AMENDMENTS TO THE DRAWINGS

Application No. 10/656,936
Paper Dated September 8, 2006
In Reply to USPTO Correspondence of May 12, 2006
Attorney Docket No. 1381-031188

FIG. 2A

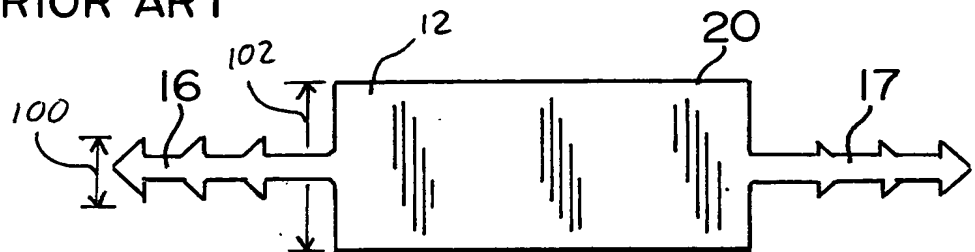
The attached sheets of drawings include changes to FIG. 2A. The replacement sheet, which includes FIGS. 1A, 1B, 2A, 2B, 2C and 2D, replaces the original sheet including FIGS. 1A, 1B, 2A, 2B, 2C and 2D. Changes incorporated in the replacement sheet are indicated in red on the attached annotated copy of the original sheet.
